RE: Amendment Application for the Namas Wind Farm (DEA ref.: 14/12/16/3/3/1/1971)

Genesis Namas Wind (Pty) Ltd received Environmental Authorisation on 18 February 2019 for the Namas Wind Farm and is proposing to amend the turbine specifications and layout of the Namas Wind Farm. As part of the Amendment Application, Savannah Environmental has requested comment from 3Foxes Biodiversity Solutions on the ecological implications of the proposed changes to the layout and turbine specifications that would be included in the Amendment.

The amended layout of the Namas Wind Farm, showing the 35 turbine layout proposed as part of the amendment.

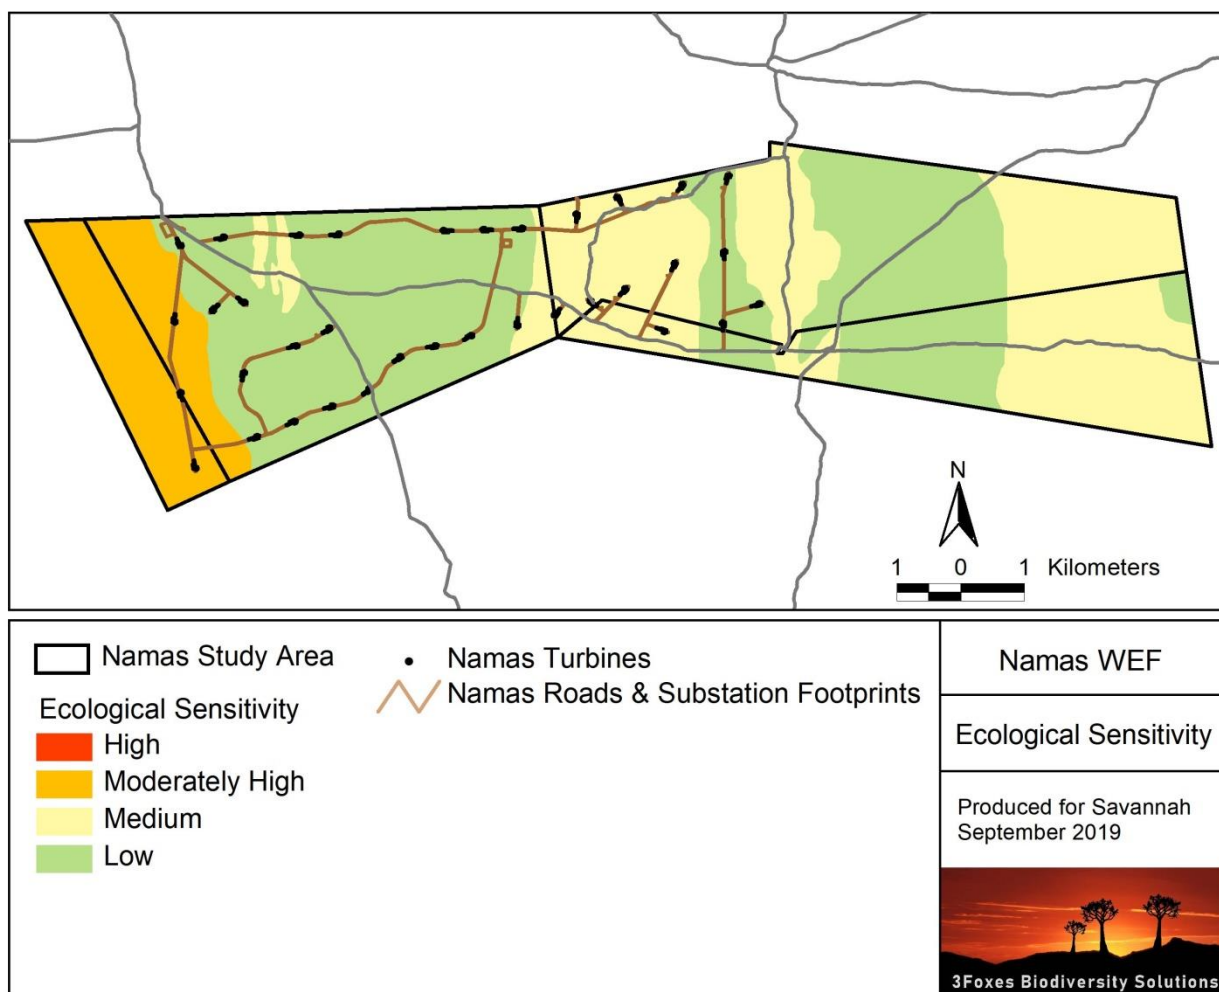
I have reviewed the proposed amended layout in reference to both the original assessed layout (containing 43 wind turbines) as well as the ecological sensitivity of the site. The ecological impact of the proposed 35 turbine layout is likely to be similar (with a negligible reduction) to the original 43 turbine layout as a result of the reduced number of turbines within the higher sensitivity parts of the site as well as the slightly reduced extent of access roads associated with the amended layout. No new impacts are expected to occur with the implementation of the amended layout. The amended layout is illustrated

below in reference to the ecological sensitivity of the site. The total footprint of the facility would be marginally reduced but this is not considered sufficient to change the overall ecological impact of the amended layout as compared to the original layout. The larger turbine size is not considered to be of consequence with regards to terrestrial impacts as, while the turbine hard stand may be larger for each turbine, the reduction in the number of turbines would compensate for any increase in footprint associated with each turbine. In addition, the reduced number of turbines would mean that the average distance between turbines is larger with the result that faunal disturbance from the turbines or maintenance activities on the wind farm during operation would potentially be slightly lower. However, taking a conservative approach in this regard, this is not deemed sufficient to warrant adjustment of the assessed impacts on fauna downward as these were already assessed as being low and consequently, there would be no overall change in the assessed impact on fauna.
